CHARTER TOWNSHIP  
OF YPSILANTI  
PLANNING COMMISSION

---

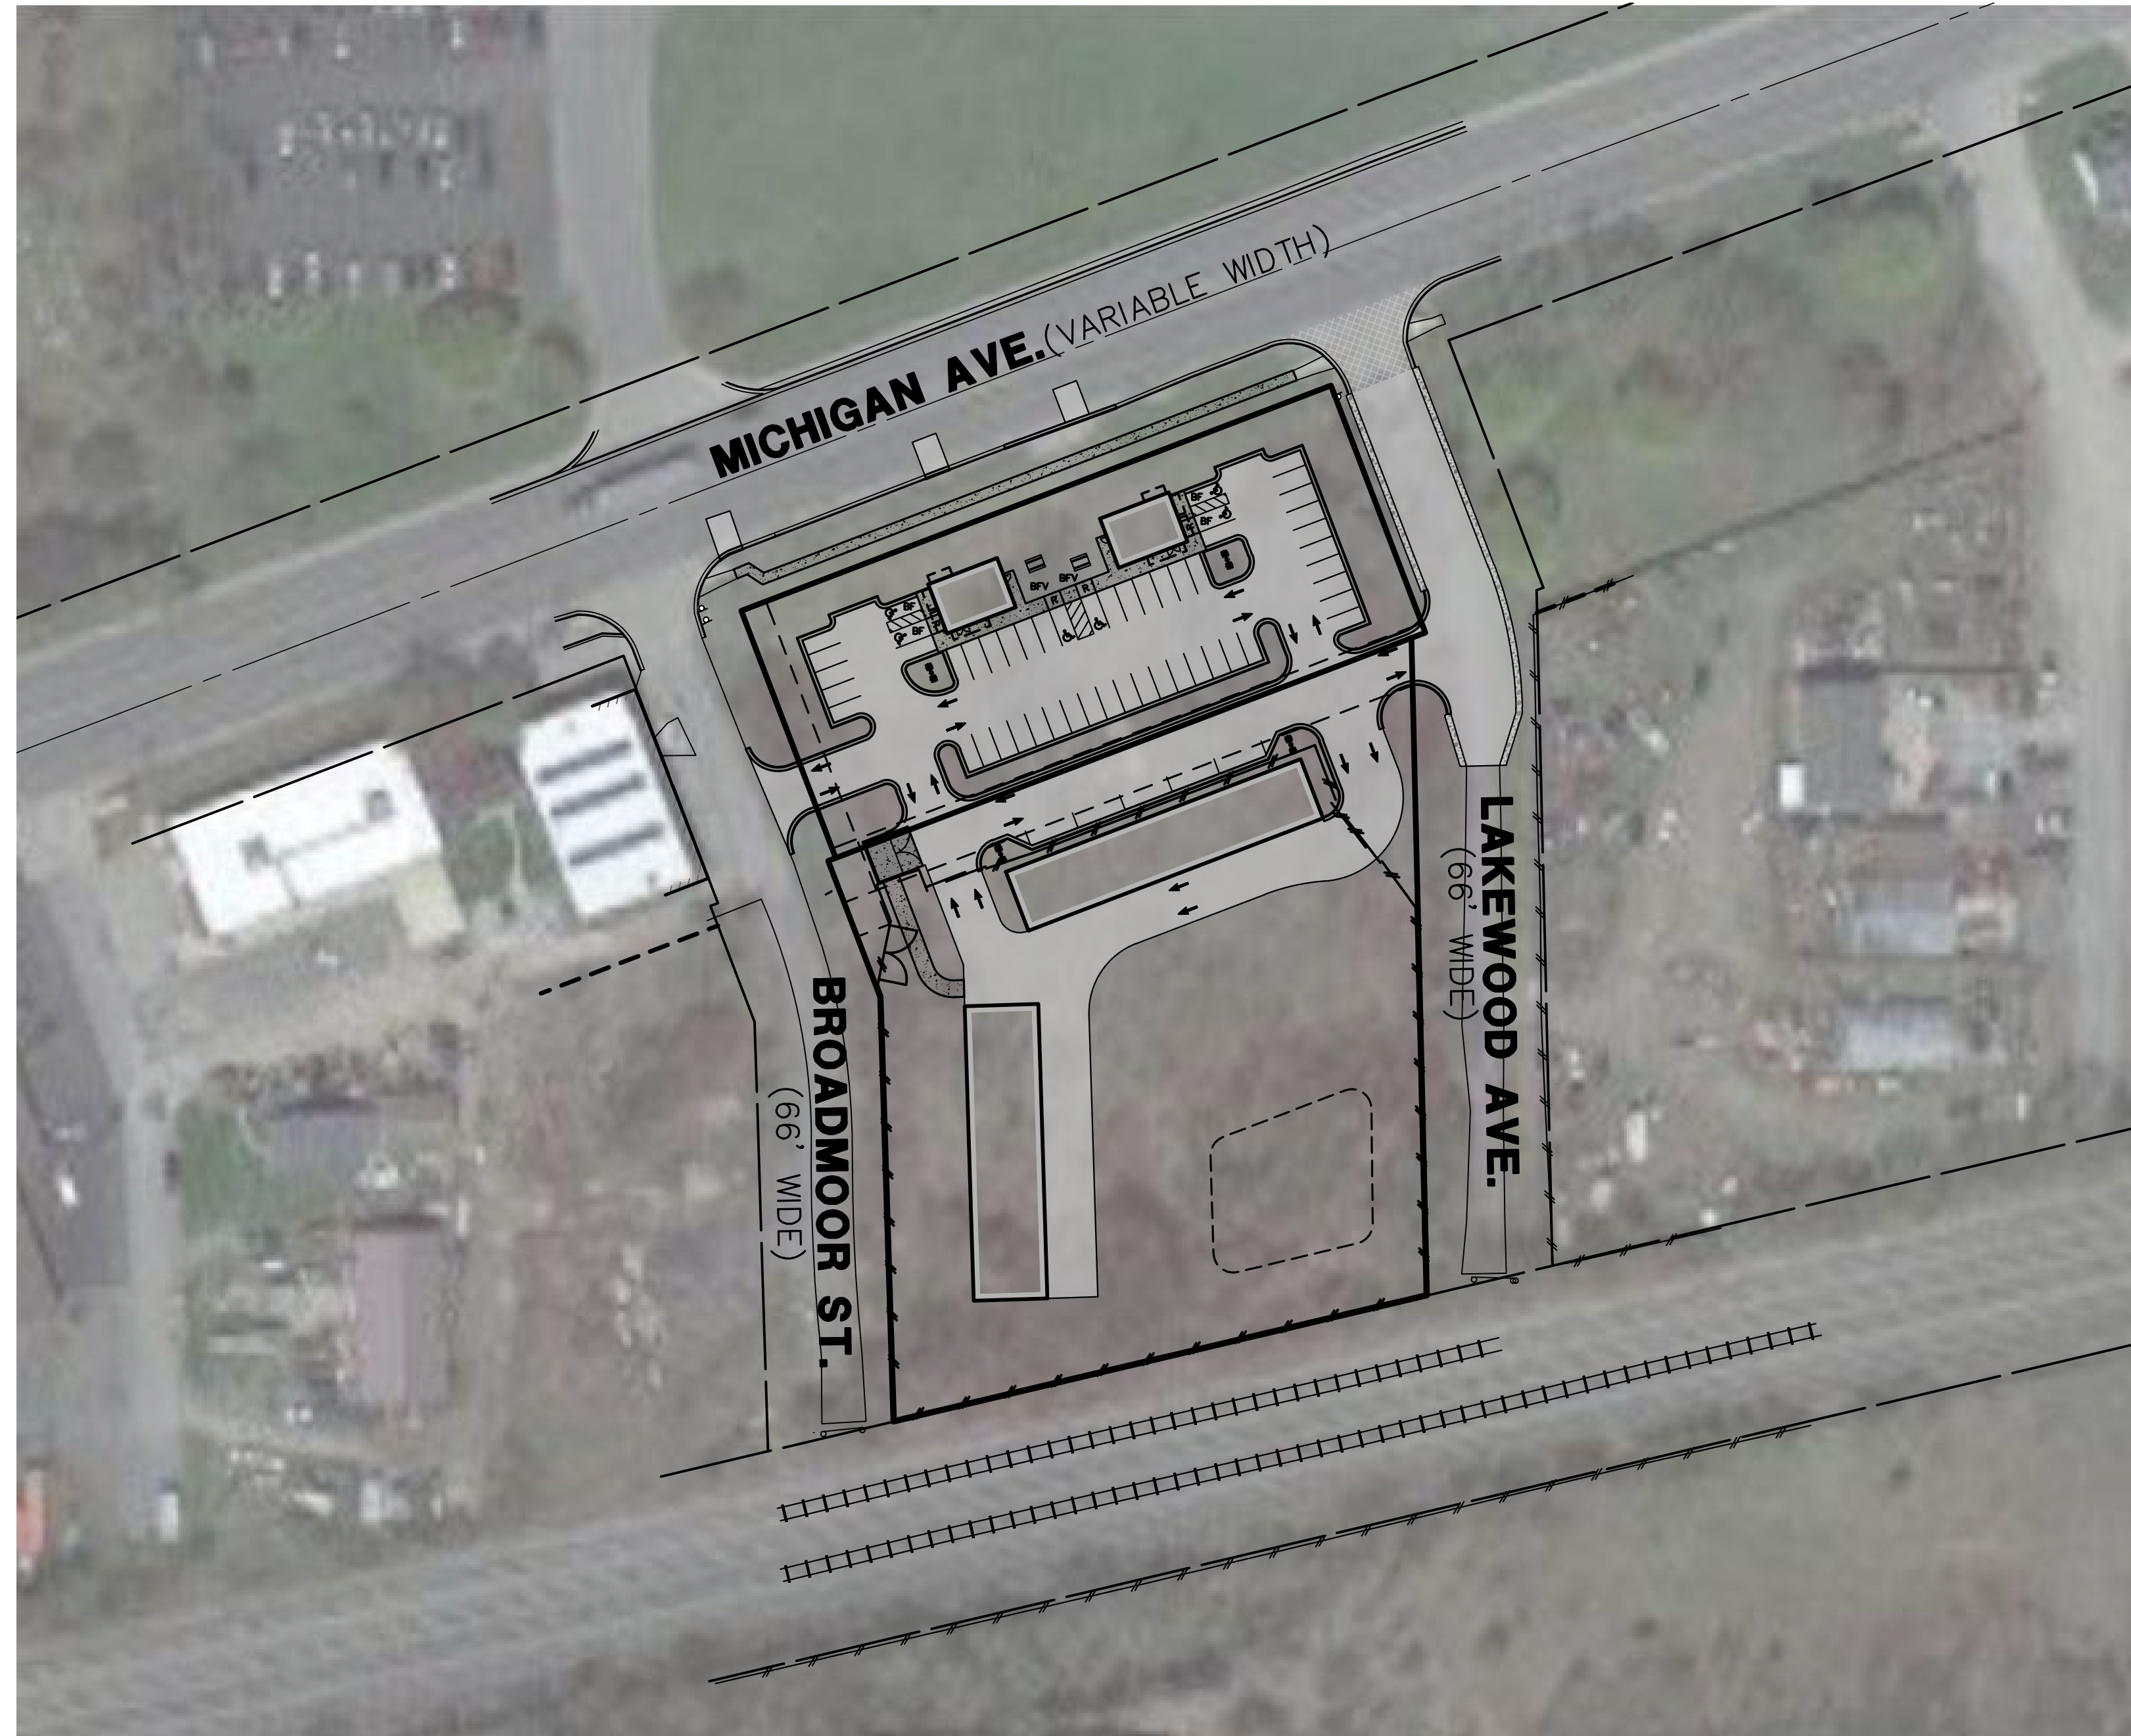
**Plan review markups 7-8-20.pdf**  
8 MB
